SA2021-922

**SUBJECT:** Substation Audit of PG&E's Martin Substation Headquarters

**CPUC SUBSTATION AUDIT FINDINGS**  
**PG&E MARTIN HEADQUARTERS**  
**July 19 - 23, 2021**

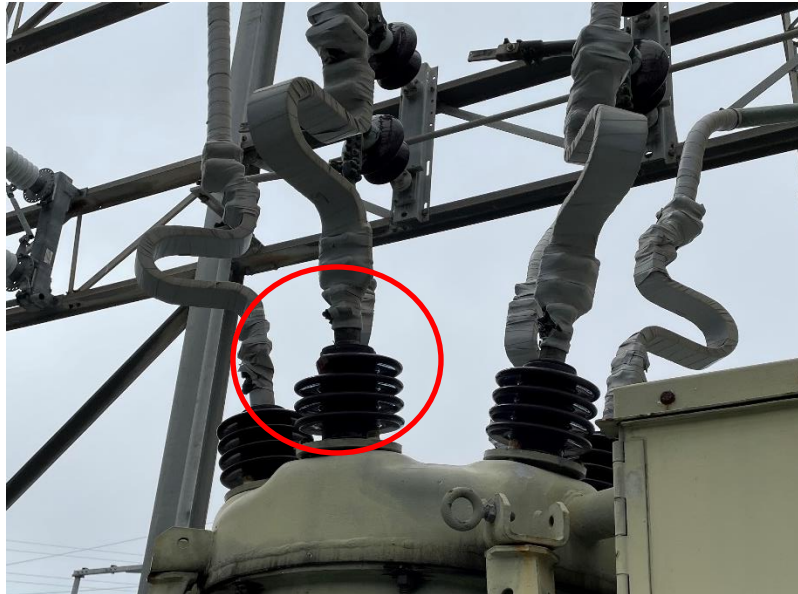
- a. Animal guard was coming off at Circuit Breaker (CB) 1106/2.

b. Animal guard was coming off at CB 1108/2.

c. Animal guard was coming off at CB 1400/2.

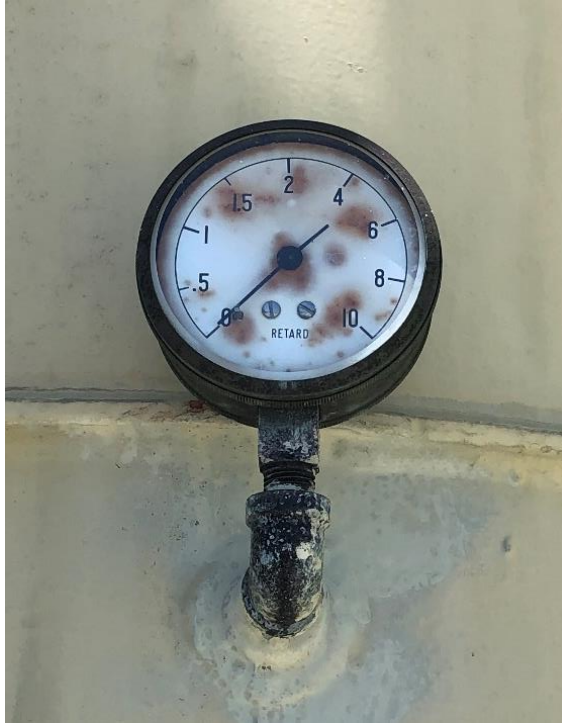
Low nitrogen pressure on Banks 1A, 1B, and 1C.
